Comboni Hospital Sakopage

Inspection of the electrical Installation:

Date of Inspection: 11/04/2016

01 ECG Æ Feedline, Overhead Transformer:

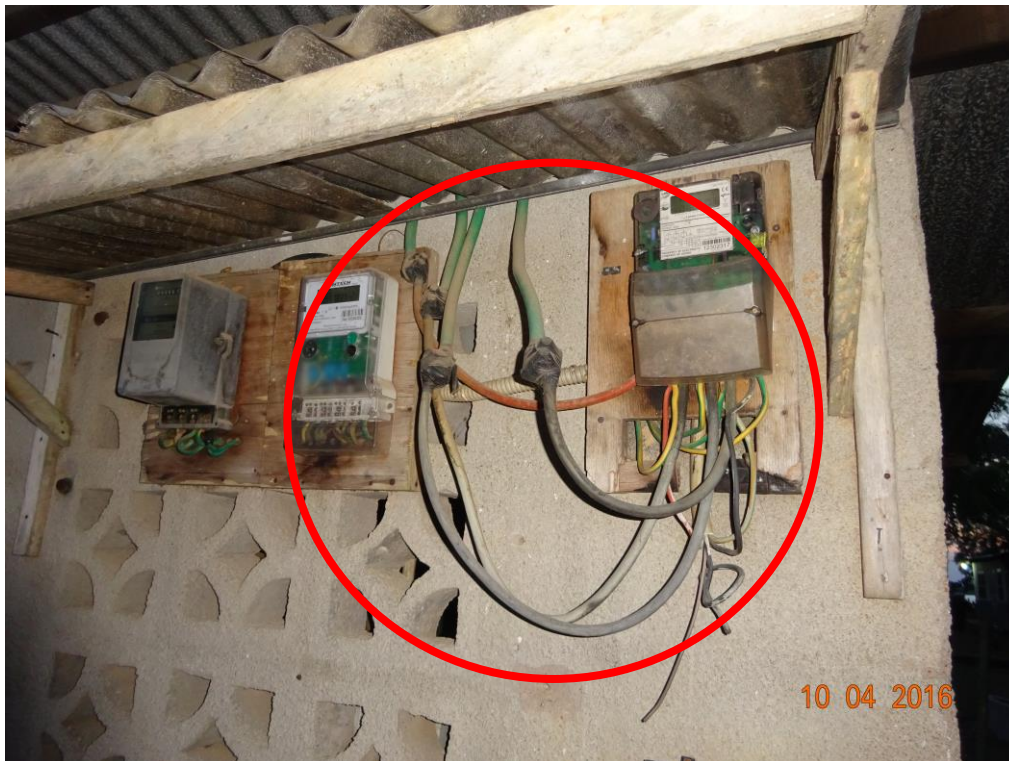
01.01 The Voltage at the actual step of the Transformer is too high.....! High voltage will affect electrical and electronic systems all over the Hospital.

The Voltage is too high. The ECG- Transformer must be stepped down to a tension of max. 235 V.

The Grounding Resistance must be below 1 Ω.

○ Twisted wire, needs good cable connectors

04 Theatre

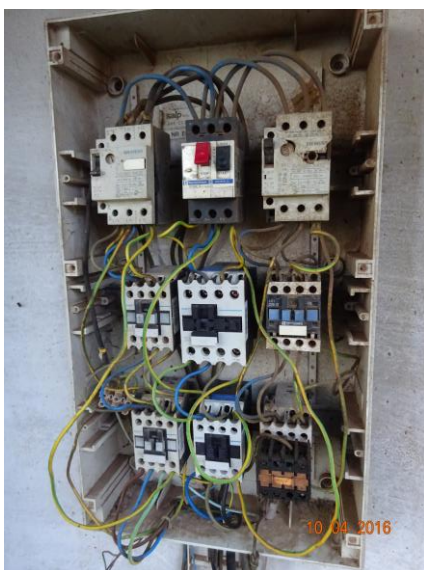
- 04.01 The whole electrical installation at the theatre is in a very bad condition and unsafe.
- 04.02 The main supply line from Powerhouse must be replaced. Size 5 x 16 mm² .
- 04.03 The junction box for the incoming cable is located on a dangerous place. The box must be fixed 1.5 m above the floor
Open connections, twisted cable connections, no way to identify the leads, not covered...

05 Hospital Main water supply

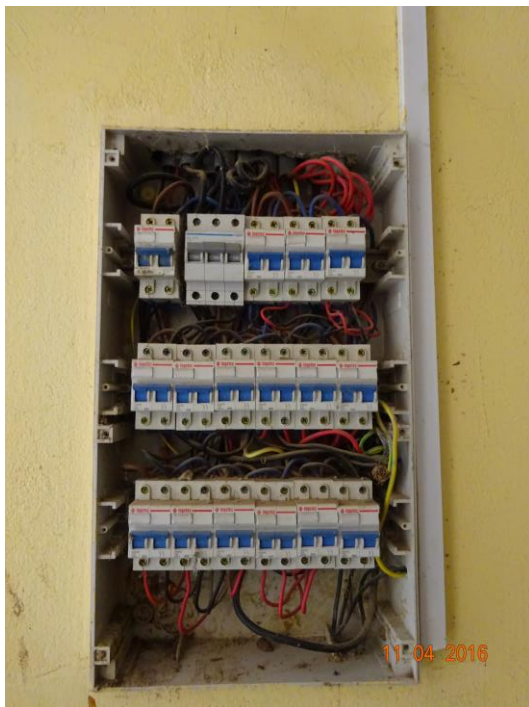
- 05.01 The Electrical connection is faulty. A new cable from the power house to the water pumping station must be installed, size 5 x 10 mm² .
- 05.02 The pump control board is in a horrible condition. Wrong coloured and flying wires, twisted wire connection, no adequate fuse, no RCD...!!
- 05.03 The pump control board is open and is affected from dust and humidity, the installation must be placed in a dust- and waterproof housing.
- 05.04 An useful Water filtering system should be installed to prevent clogging the pipes.
